March 27, 2024

Subject: Planning Board Peer Review  
Proposed Eversource Training Facility  
37 Doty Street  
Wareham, Massachusetts 02576  
CEC Project 323-322

On behalf of the applicant for the above referenced property NStar Electric Co. d/b/a Eversource Energy (Eversource), Civil & Environmental Consultants, Inc. (“CEC”) has prepared this memorandum in response to comments provided in a memorandum from Allen & Major Associates, Inc. (“A&M”), dated March 14, 2024.

**TREE PROTECTION FENCE**  
N.T.S.

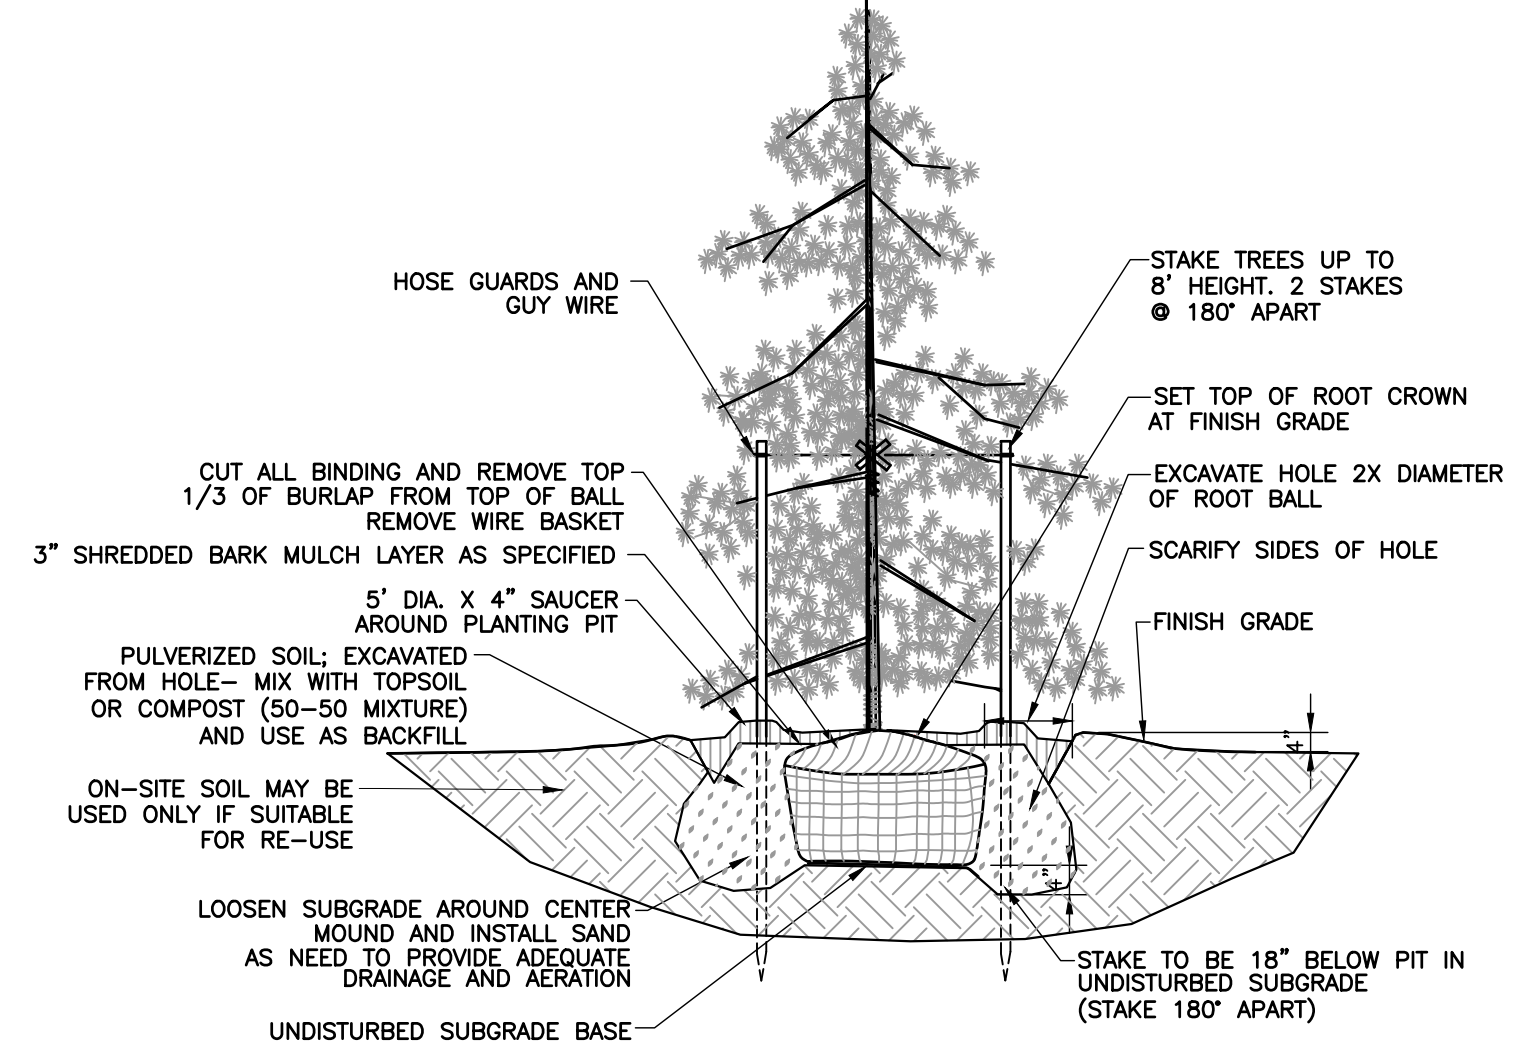
**Updated Comment:** The limits of clearing have not been provided on the revised drawings. The plan also denotes “existing trees to be protected during construction” (Sheet C700) but do not indicate any particular trees or methods of adequate protection. A&M defers to the Planning Board on the adequacy of the existing trees and the amount of tree removal requested.

**CEC Response:** The limit of clearing has been added to the revised drawings. Where feasible vegetation will be maintained. A tree protection fencing detail has been added for the trees that are proposed to remain. See Sheet C701.

**SECTION A-A**  
**STORMCEPTOR STC 450i DETAIL**  
(NOT TO SCALE)

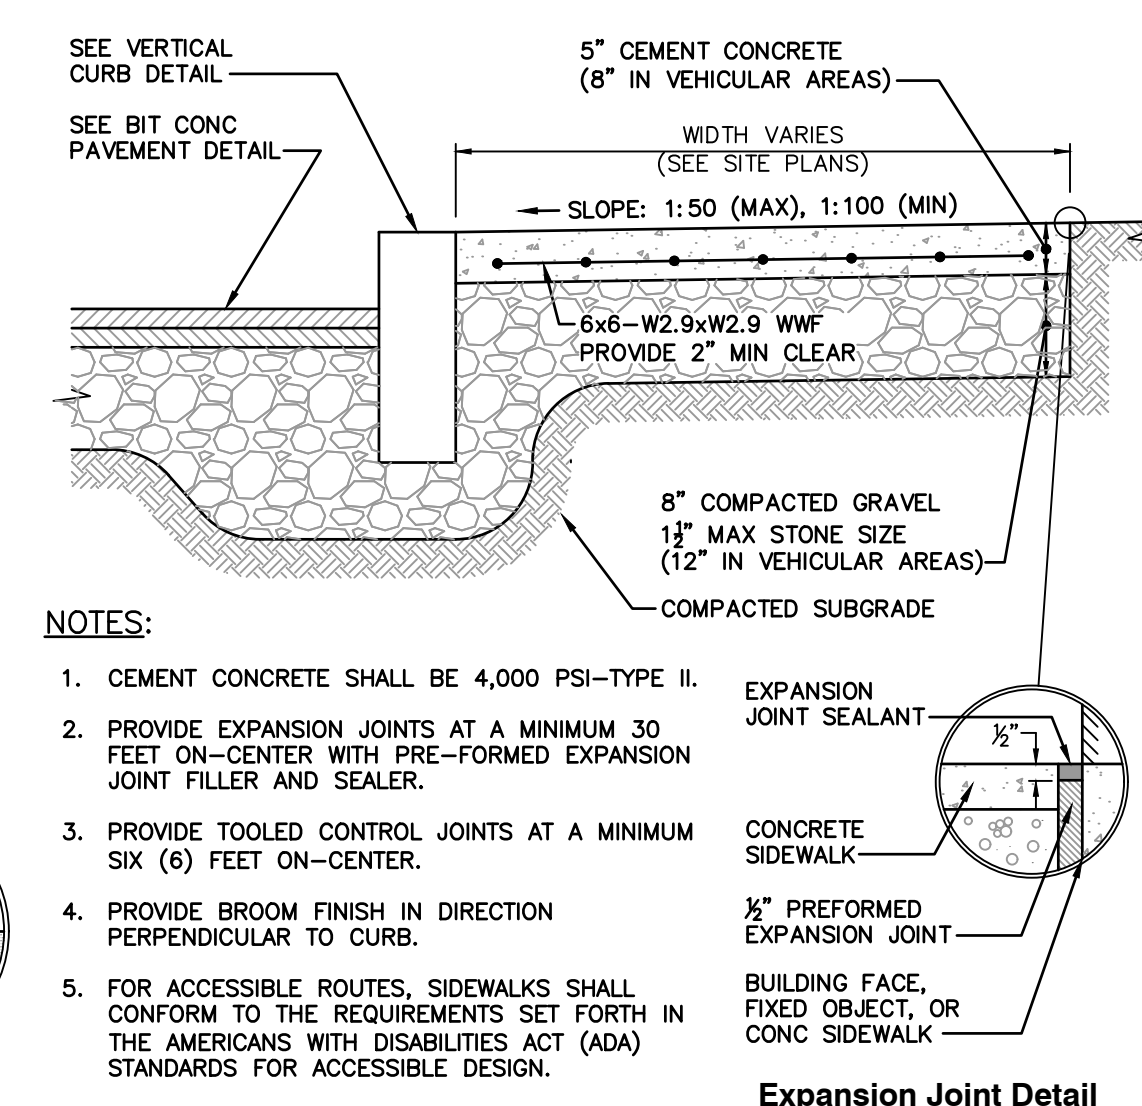
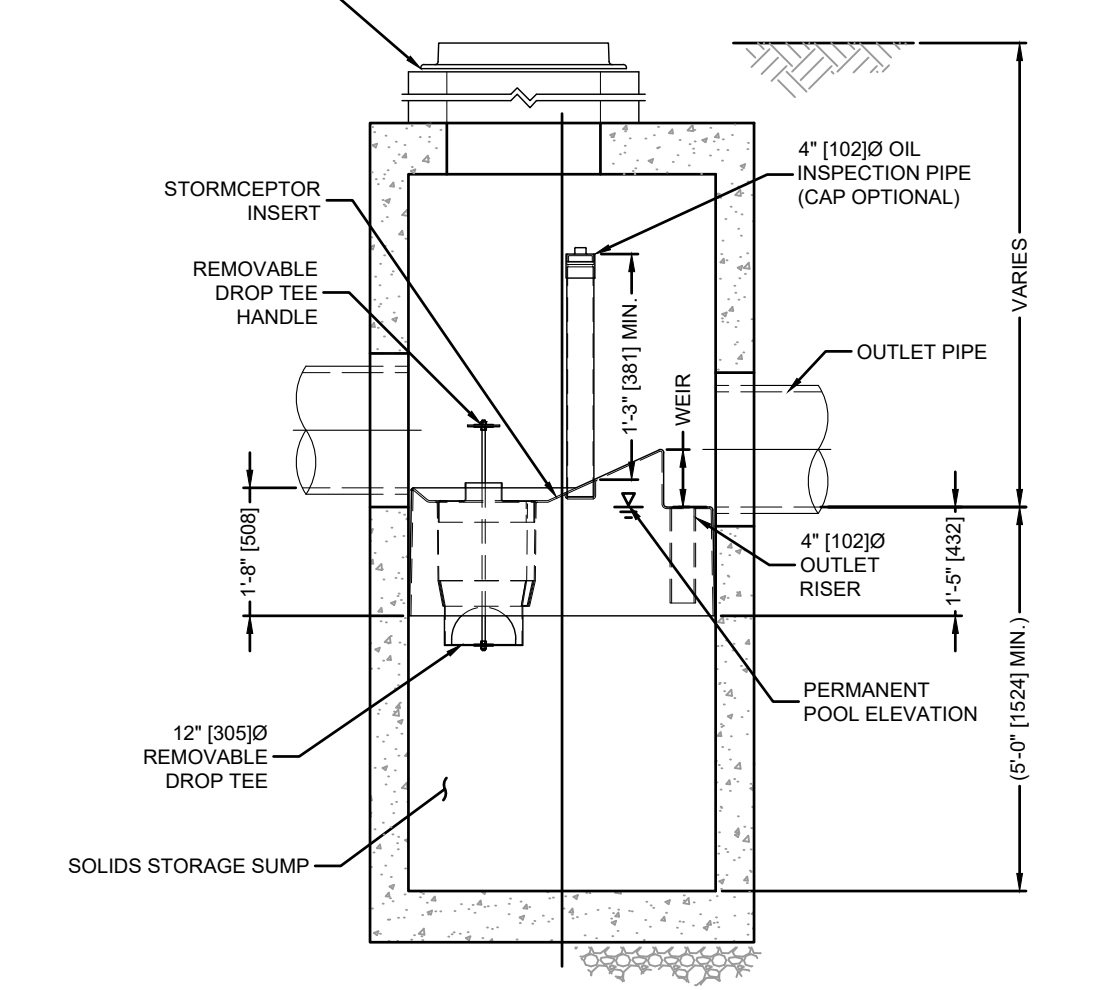
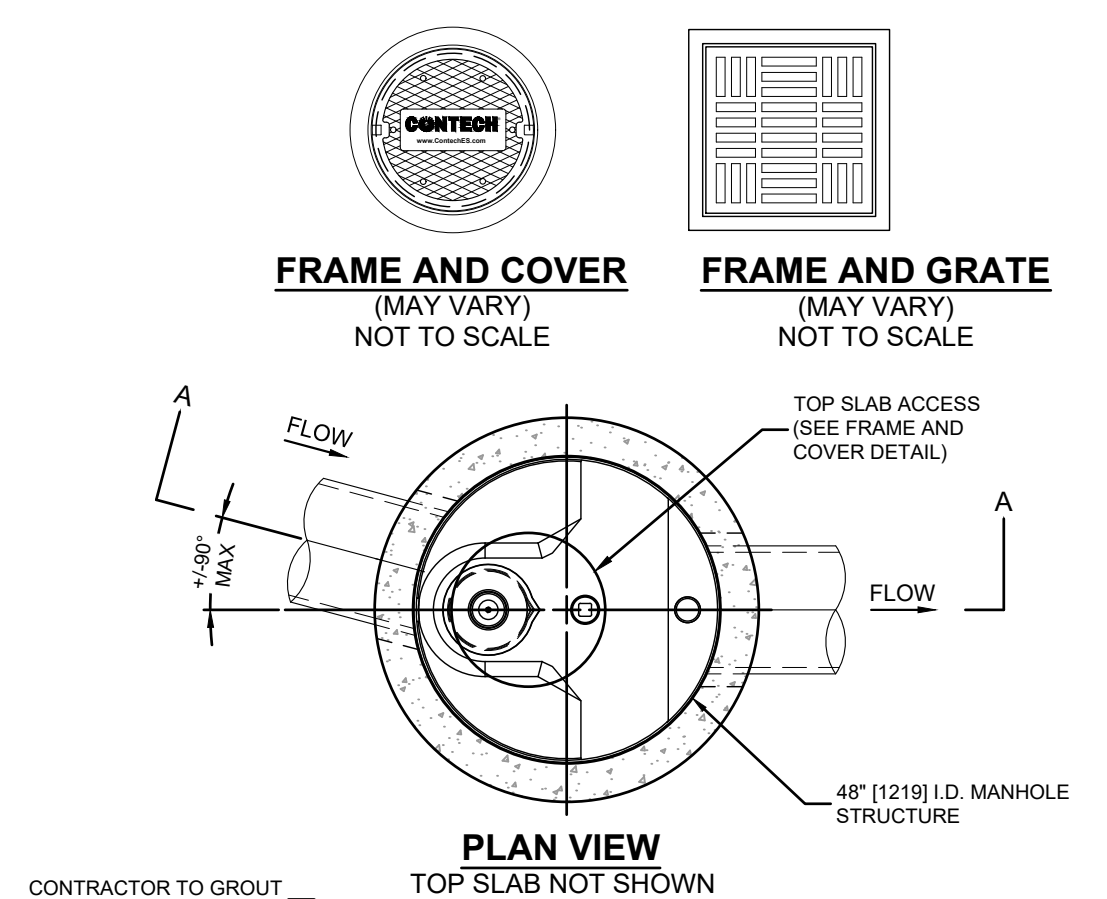
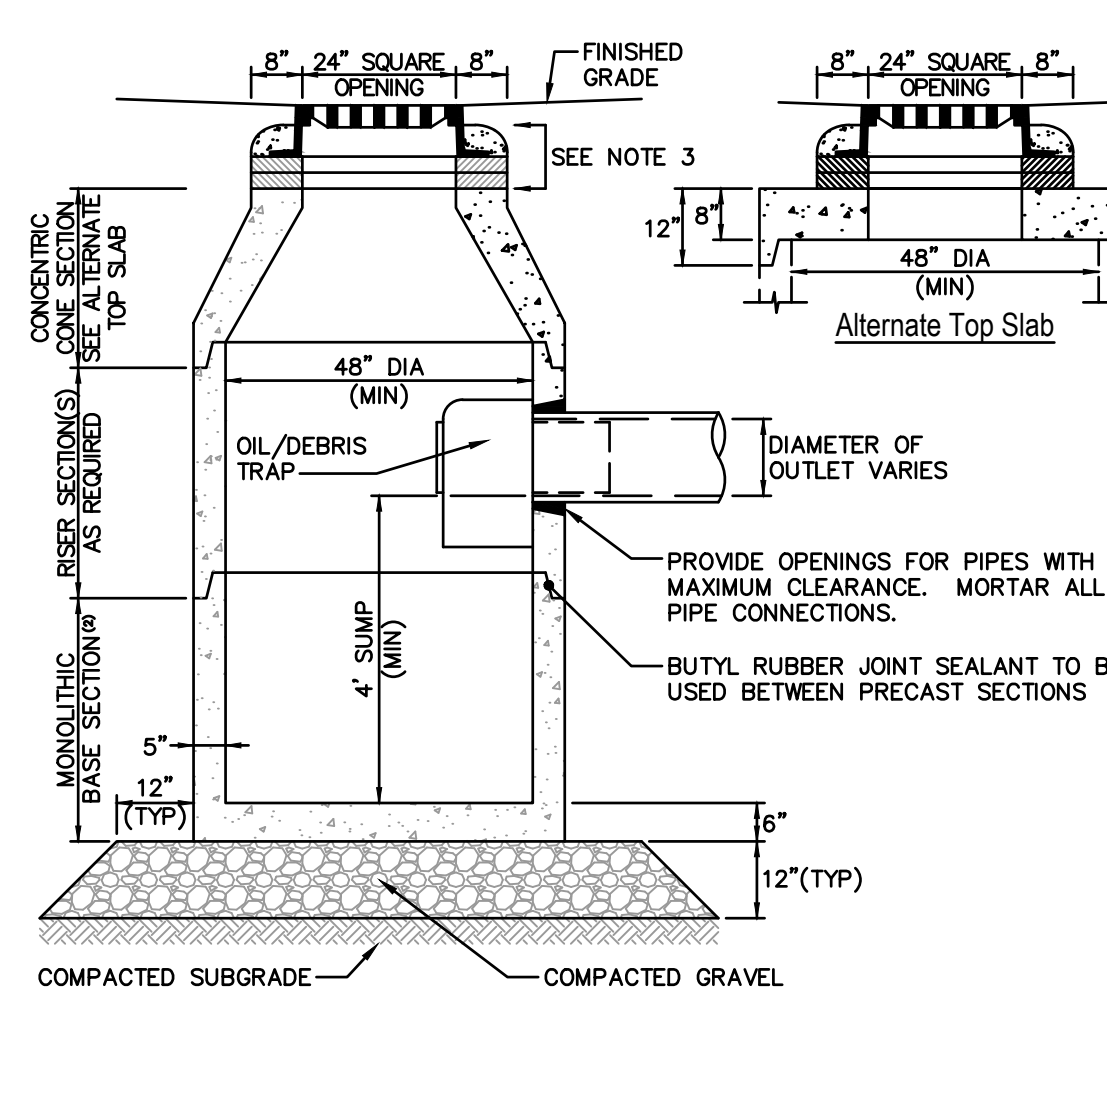
28. The TSS removal worksheet associated with BMP Treatment Train 2 calls for a Stormceptor 450i and the wet basin with a sediment forebay. A&M is unable to find the location of the Stormceptor 450i on the plans. The design engineer should identify the water quality structure on the plans and provide the appropriate details.

**CEC Response: The drawings have been updated to label the existing catchbasin to be removed and to be replaced with a Stormceptor 450i water quality unit.**
